CUBEX LTD.
PRODUCT UPDATE

BULLETIN: PU-0010

SUBJECT: TELESCOPIC CYLINDER MOUNTING CHANGED

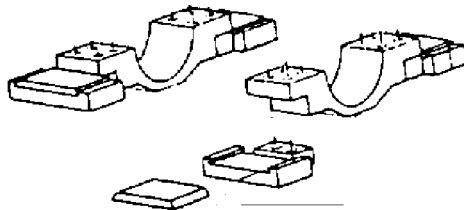
INFORMATION: FORMER BRACKETS
The former mounting brackets utilized 8 CAM rollers to guide the telescopic cylinder on the guide bars.

CURRENT BRACKETS
The new brackets use replacement wear inserts to guide the telescopic cylinder on guide bars.

The new mounting system will provide longer service life than the former CAM rollers.

Parts required to install the change up:
2 - #CM45222 CLAMP ASSEMBLY
4 - #CM45224 SHIM PACK
